**Report: TAB Report**  
**Function: Test, Adjust, & Balance**  
**Date: 06/27/2024**

**PROJECT**  
**06-24-24 WAWA #5413 SARASOTA, FL**

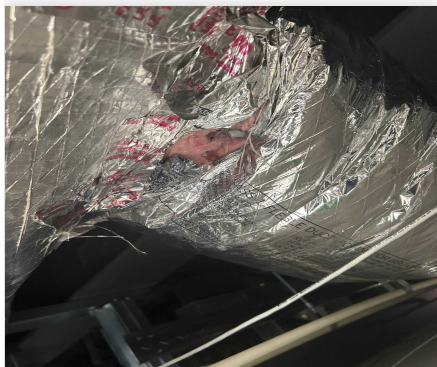
**Issue Name :** Diffuser 2-1 - damper missing wing nut  
**Description :** Diffuser 2-1 currently has an airflow of 677 CFM (135% of design) and cannot be lowered because the damper will not hold the required position; it is missing a wing nut opposite the handle. Recommend repairing damper to allow for airflow adjustment.  
**Created By :** National TAB                      **Assigned To :** National TAB - Mark Johnson  
**Status :** Open  
**Priority :** High                                      **Asset Tag :**  
**Originated Date :** 06/26/2024 - Mark Johnson - National TAB

- **06/30/2024 National TAB - Mark Johnson**
  - Mechanical clarified that damper design does not require second wing nut, and tightened handle to allow for adjustment. Could not re-adjust on site under time constraint.

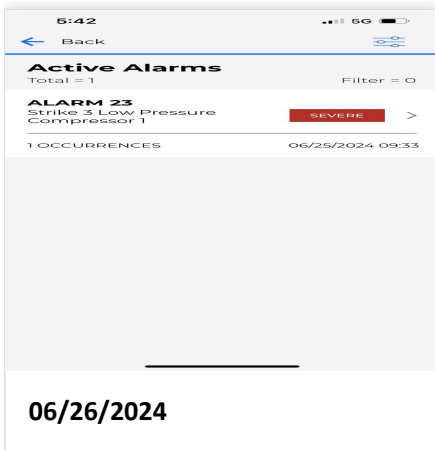
**Issue Name :** EF-2 low flow  
**Description :** EF-2 is experiencing low exhaust flow (22 CFM, 37% of design) after installation of speed controller. Additionally, the fan is starting and stopping at frequent intervals. Fan is set to max speed. Recommend checking speed controller and wiring for possible faults.  
**Created By :** National TAB                      **Assigned To :** National TAB - Mark Johnson  
**Status :** Closed  
**Priority :** High                                      **Asset Tag :**  
**Originated Date :** 06/30/2024 - Mark Johnson - National TAB

Asset: EF2

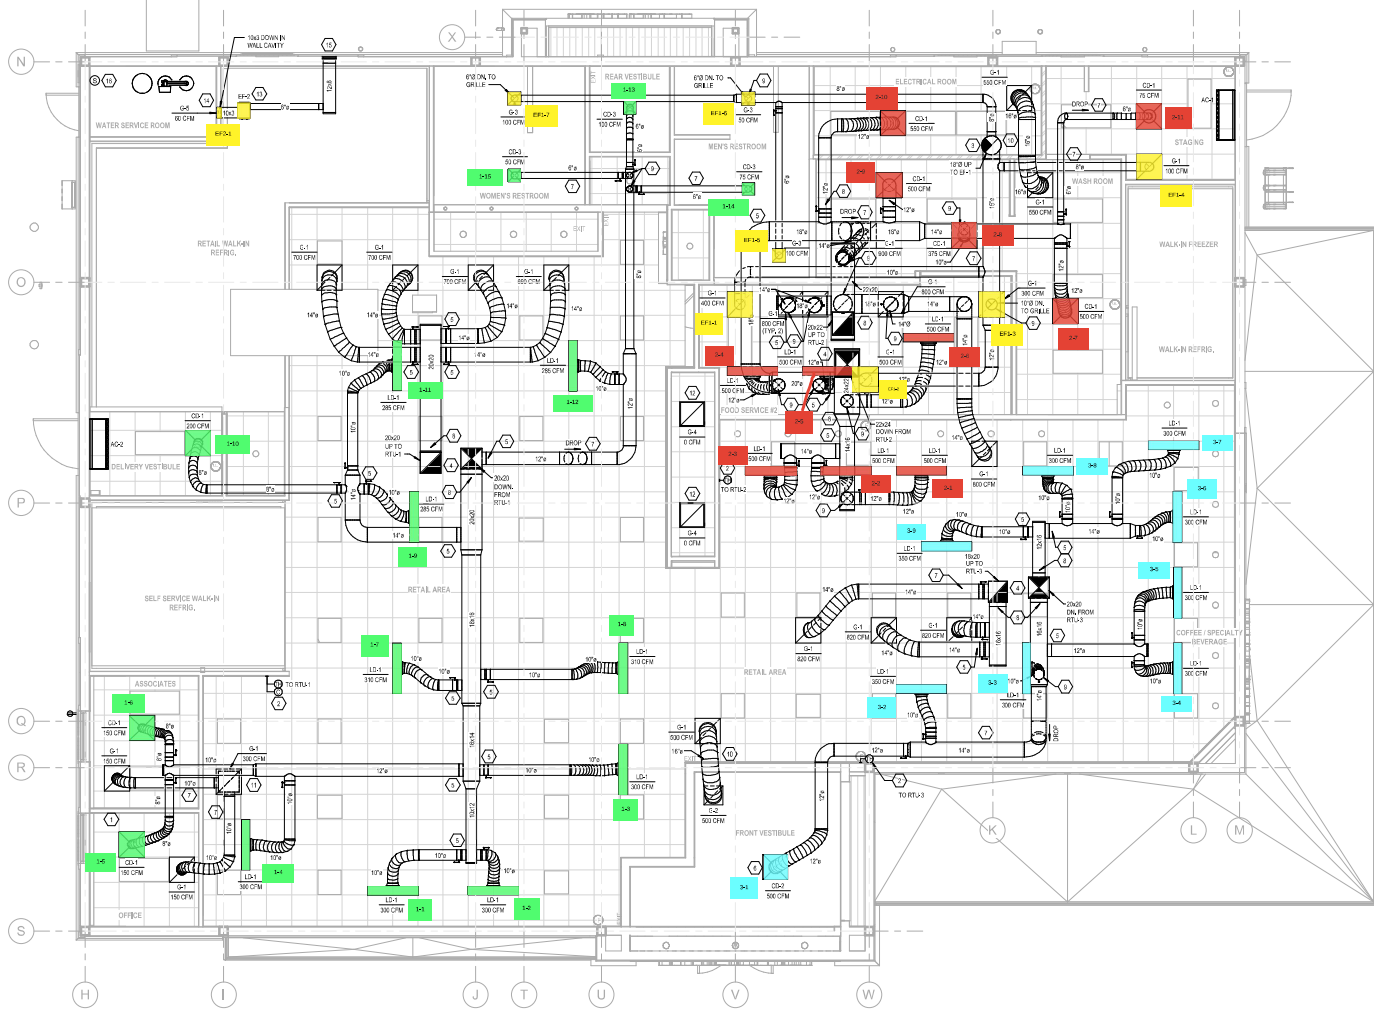
EF-2 is currently at 37% of design exhaust flow. All other exhaust grilles and totals are within required design.
